IN THE DRAWINGS:

REMARKS

Present Invention

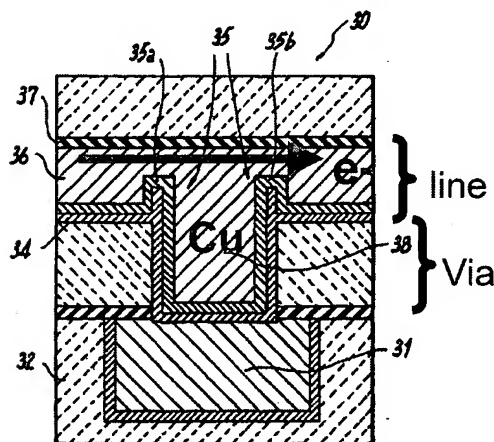
Applicants respectfully disagree. As shown illustrated below, Figure 2 of the present drawings depict the embodiment described in Wang (e.g., corresponding to Figures 2H and 2L of Wang), which clearly shows, after a second chemical mechanical polish step, the resulting structure where the liner material 25, 25a and 25b completely blocks the electro path in the line level. In the present invention shown below, and as set forth in Claims 1 and 5, only a portion of the metal liner extends partially into an adjacent metal level of the first and second metal levels. Clearly, Wang does not teach or suggest such a feature. Wang show a process for fully encapsulating a copper via in a semiconductor device as a way to prevent void formation in the bottom of the via due to electromigration.

However, the present invention enhances the electromigration resistance, i.e., slows down electromigration phenomena (see paragraph [0034] of the present specification) by extending a portion of the metal liner partially into an adjacent metal level of the first and second metal levels which structure is neither taught by nor suggested in Wang. This partial extension of the liner according to the invention forces electrons to go “around the fence” and flow down through the via that eliminating the current crowding effect and thus, less migration.

**FIG. 2
Prior Art**

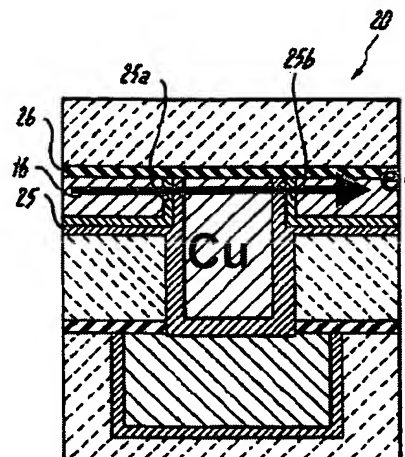
Further in the Office Action, the Examiner rejected Claims 1-6 under 35 U.S.C. §102(b) as allegedly being anticipated by Wang et al. (U.S. Patent No. 6,383,920) ("Wang").
